Project	IEEE 802.16 Broadband Wireless Access Working Group <http://ieee802.org/16>	
Title	Security Association Establishment for PKMv2-EAP	
Date Submitted	2004-11-04	
Source(s)	Mi-young Yun Jung-mo Moon Chulsik Yoon Young-jin Kim, ETRI 161, Gajeong-dong, Yuseong-Gu, Daejeon, 305-350, Korea	Voice: +82-42-860-4821 Fax: +82-42-861-1966 myyun@etri.re.kr
Re:	Contribution to P802.16e/D5	
Abstract	We propose to add and modify the EAP authentication and key distribution mechanism in the current TGe document on the basis of PKMv2-EAP mechanism.	
Purpose	Adoption	
Notice	This document has been prepared to assist IEEE 802.16. It is offered as a basis for discussion and is not binding on the contributing individual(s) or organization(s). The material in this document is subject to change in form and content after further study. The contributor(s) reserve(s) the right to add, amend or withdraw material contained herein.

Security Association Establishment for PKMv2-EAP

Mi-young Yun, Jung-mo Moon, Chulsik Yoon, Young-jin Kim

Figure 5. Proposed PKMv2-EAP-only mode authentication

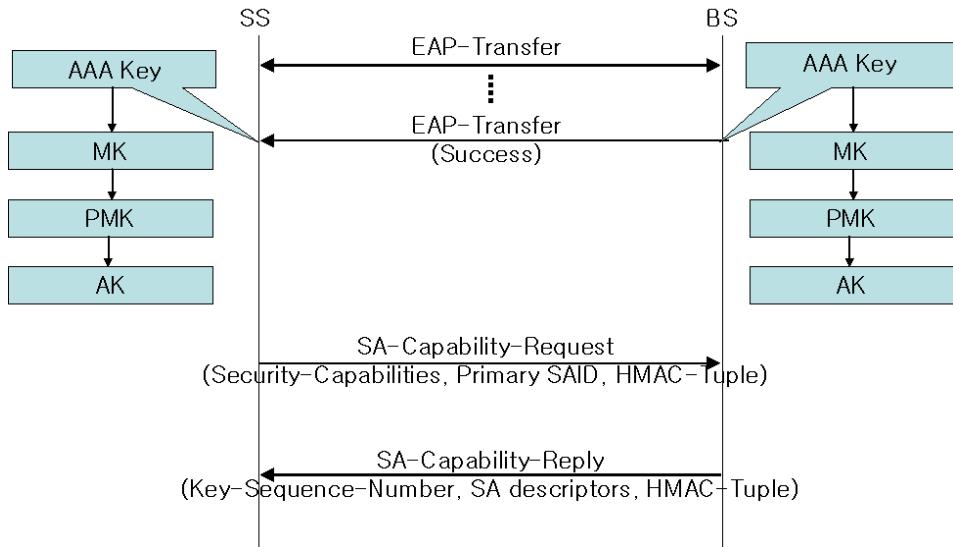
Accordingly, we define SA-Capability-Request and SA-Capability-Reply messages which can be validated by HMAC Tuple.

The proposed EAP-only mode authentication flow with SA-Capability messages is shown in Figure 5. The SA-Capability negotiation flow is shown in Figure 6 when the pre-authentication is used.
